Intersection Road Safety Audit

SR 17 AT SANDHILL ROAD / MARLOW ROAD

Prepared for the Georgia Department of Transportation

December 2016

FIGURE 4-7. RECOMMENDED SHORT TERM PAVEMENT MARKING IMPROVEMENTS

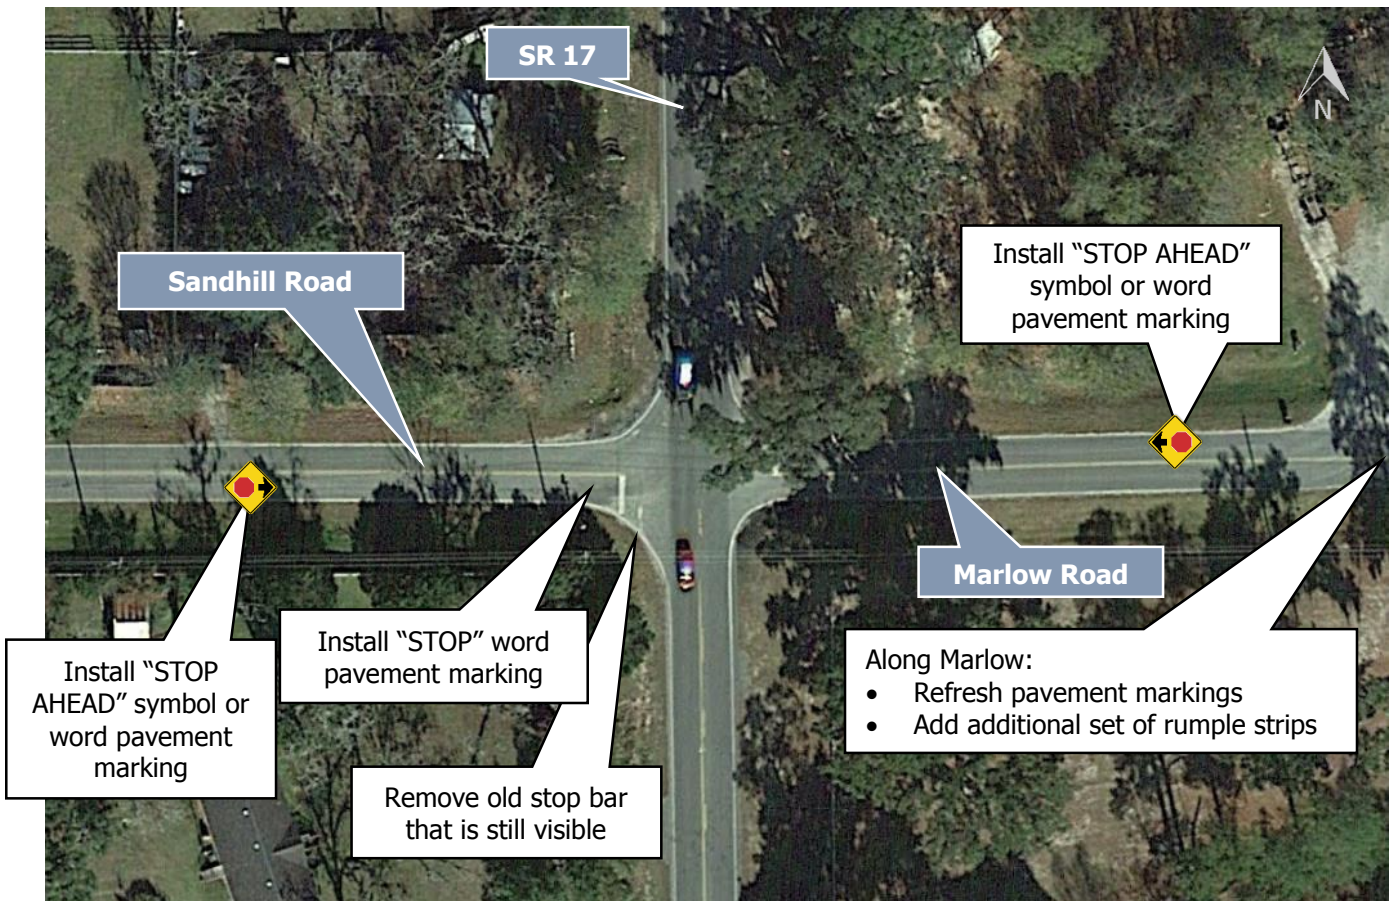
1. Three sets of transverse rumble strips (Figure 4-2) are present on Marlow Road approaching the intersection. Advance warning "Stop Ahead" signs and word pavement markings are used to supplement the rumble strips. The audit team noted that the rumble strips are located far from the study intersection. An additional set closer to the intersection would enhance their purpose.

2. There is a "STOP" word pavement marking on the Marlow Road intersection approach just before the stop bar. The Sandhill Road approach has no such pavement marking.

7. There is a lack of line extensions (dashed or solid white lines) on SR 17 through the intersection. Line extensions may help call attention to the cross street.

8. Along Marlow Road, approaching the intersection, grass and other vegetation has grown over the shoulder and covers the edge line pavement markings.
9. The old (former) stop bar on the Sandhill Road approach is worn yet is still visible (located approximately six feet closer to the center of the intersection than the new one, see Figure 4-4), even though a new stop bar has been installed. This may be potentially confusing to motorists.

SAFETY BENEFIT	LEVEL OF EFFORT	TIME FRAME	COST
1. Install "Stop" word pavement marking on Sandhill Road approach.	High	Low	Short Term	Low
2. Consider installing "Stop Ahead" symbol advance warning pavement markings on Marlow Road and Sandhill Road approaches to raise driver awareness of the stop control at the intersection with SR 17.	Moderate	Low	Short Term	Low

3. Work with Effingham County to replace pavement markings and striping along Marlow Road approaching the study intersection (Marlow Road is a County Road).	High	Low	Short Term	Low

4. Work with Effingham County to refresh pavement markings throughout the study area, especially at the intersection of Sandhill Road at Sandhill Road/Central Ave.	High	Low	Short Term	Low

5. Clear debris and vegetation covering existing pavement markings, such as edge lines.	Low	Low	Short Term	Low
6. Remove former, yet still visible, worn stop bar on Sandhill Road approach to avoid potential confusion, since a newer stop bar has recently been installed.	Low	Low	Short Term	Low

7. Consider installing additional transverse (a.k.a. in-lane) rumble strips on Marlow Road closer to the intersection to alert motorists to the stop sign ahead. Ensure at least one set of rumble strips is placed between Hickory Ln and SR 17 to warn drivers existing nearby driveways on the approach to SR 17.	Moderate	Moderate	Intermediate	Moderate

FIGURE 4-18. RECOMMENDED SHORT TERM INTERSECTION GEOMETRY IMPROVEMENTS

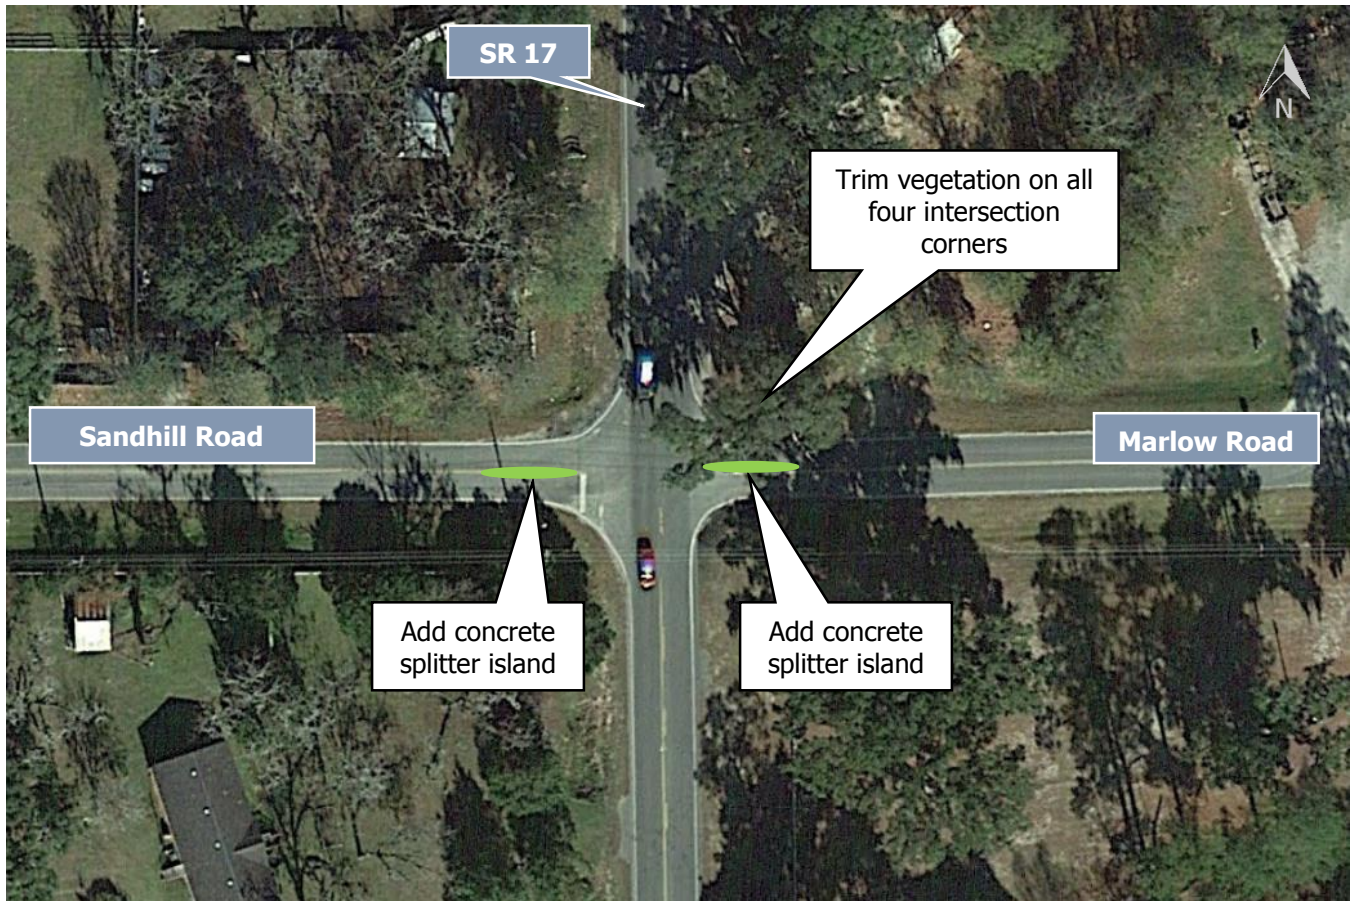
1. There are potential sight distance issues for the Marlow Road and Sandhill Road approaches – it is difficult to see when turning onto SR 17. The audit team noted that it appears that intersection ahead signs on SR 17 may block view of approaching traffic for vehicles waiting at the intersection on Sandhill Road.

2. Trees and vegetation on intersection corners partially block sight lines and limit sight distance of vehicles traveling on SR 17. Although there are advance warning signs, drivers may not be aware of the intersection due to vegetation along the roadway.

3. A white fence on the church property in the southeast corner of the intersection may obscure the view of SR 17 from the Marlow Road approach.
4. The horizontal curve approximately 700 feet east of the study intersection along Marlow Road may limit sight distance. The audit team observed heavy vegetation growing that may obscure the view of the study intersection. Marlow Road is a County Road, therefore improvements to this portion of the road (away from the intersection at SR 17) would be the County's responsibility.

SAFETY BENEFIT	LEVEL OF EFFORT	TIME FRAME	COST
1. Investigate sight distance at all intersection approaches and implement recommendations as appropriate, including trimming back or removing trees and vegetation.	Moderate	Low	Intermediate	Low
2. Install a narrow raised concrete splitter island with delineator posts on the side street approaches to SR 17 to channelize turning movements and help communicate the presence of the intersection to approaching motorists.	High	Moderate	Intermediate	Moderate
3. Trim/maintain vegetation near horizontal curve on Marlow Road.	Low	Low	Short Term	Low

FIGURE 4-20. VIEW OF INTERSECTION AT NIGHT. THERE ARE NO STREET LIGHTS OR OTHER LIGHTING PRESENT

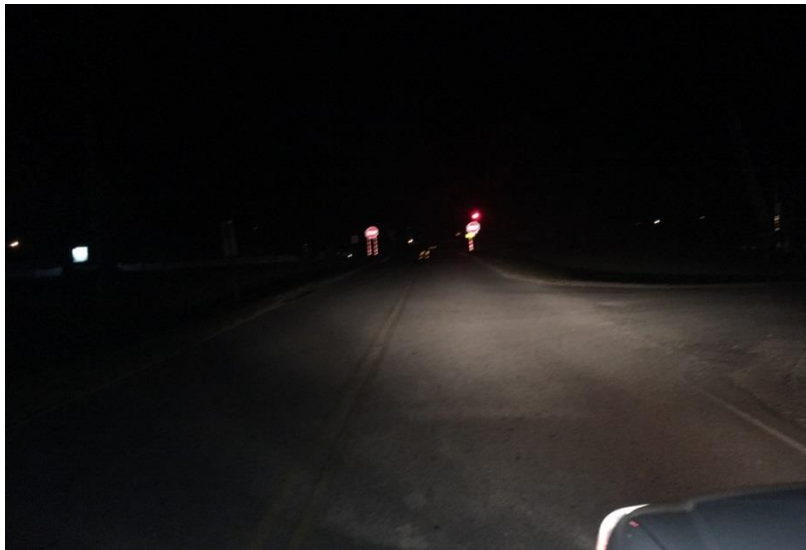
- 1. There are no street lights or other lighting in this area. It may be difficult for motorists on both roadways to see the intersection at night.
- 2. Rutting is evident in all corners of the intersection, particularly in the southeast corner, from northbound turning vehicles driving over the shoulder.

SAFETY BENEFIT	LEVEL OF EFFORT	TIME FRAME	COST
1. Install general lighting at the intersection to increase visibility and to illuminate the intersection itself.	High	Moderate	Intermediate	Moderate
